State of New Mexico  
Energy, Minerals and Natural Resources Department

**30-039-24412 CARRACAS 22A #013**

UNITED STATES  
DEPARTMENT OF THE INTERIOR  
BUREAU OF LAND MANAGEMENTFORM APPROVED  
OMB NO. 1004-0137  
Expires: January 31, 2018**SUNDRY NOTICES AND REPORTS ON WELLS**  
**Do not use this form for proposals to drill or to re-enter an abandoned well. Use form 3160-3 (APD) for such proposals.**5. Lease Serial No.  
NMNM30351

## PROPOSED P&A PROCEDURE

PROPOSED P&A – 09/03/2019

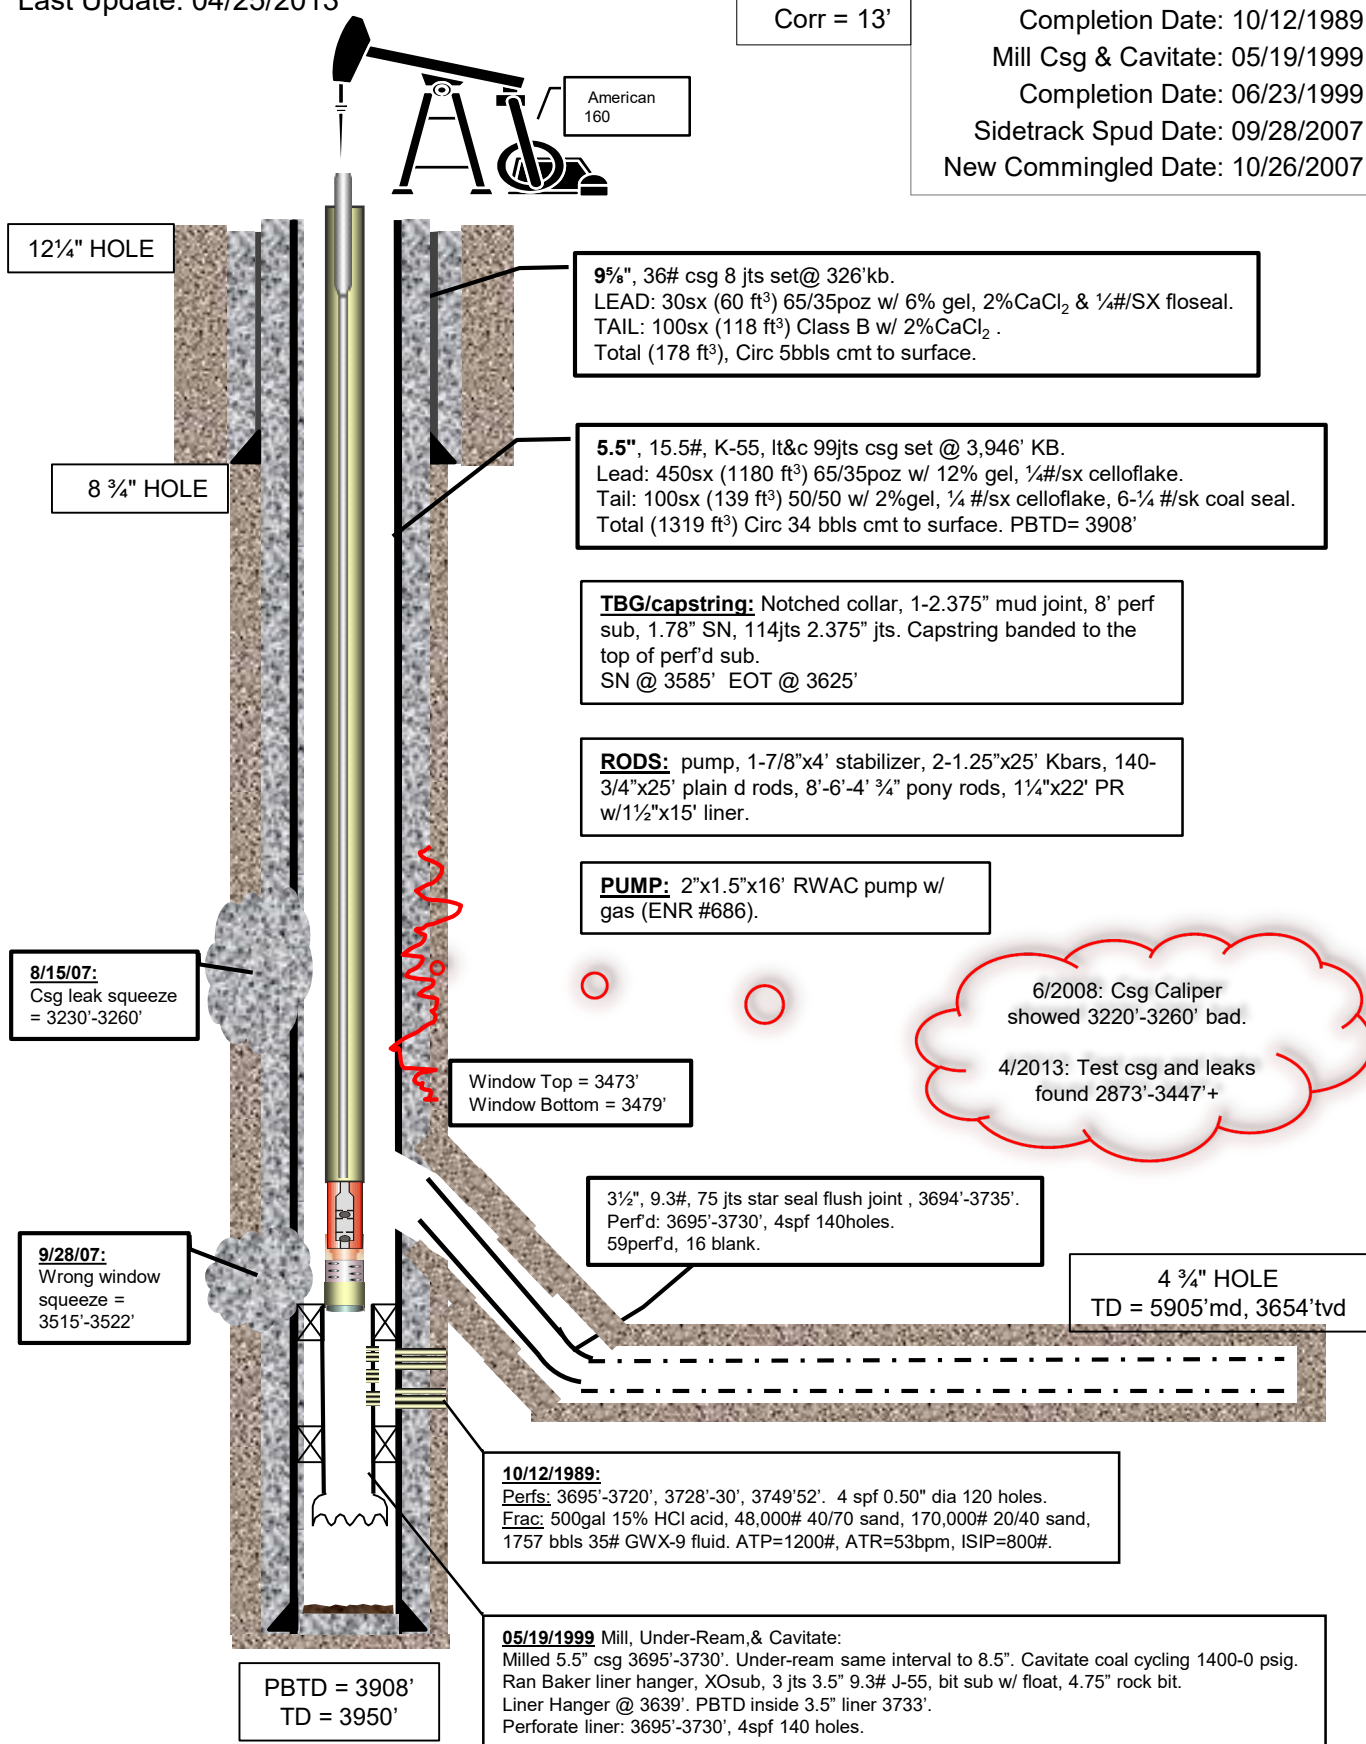
- Notify NMOCD 24 Hours prior to commencing activities
- In addition to the BLM approved plugs:
- Add a Nacimiento plug: 1850'-1750'. OCD Nacimiento pick @ 1800'.

- Please ensure that the top of the Fruitland formation as well as the entire Ojo Alamo aquifer, identified in this report, are isolated by proper placement of cement plugs. This will protect the freshwater sands in this well bore.
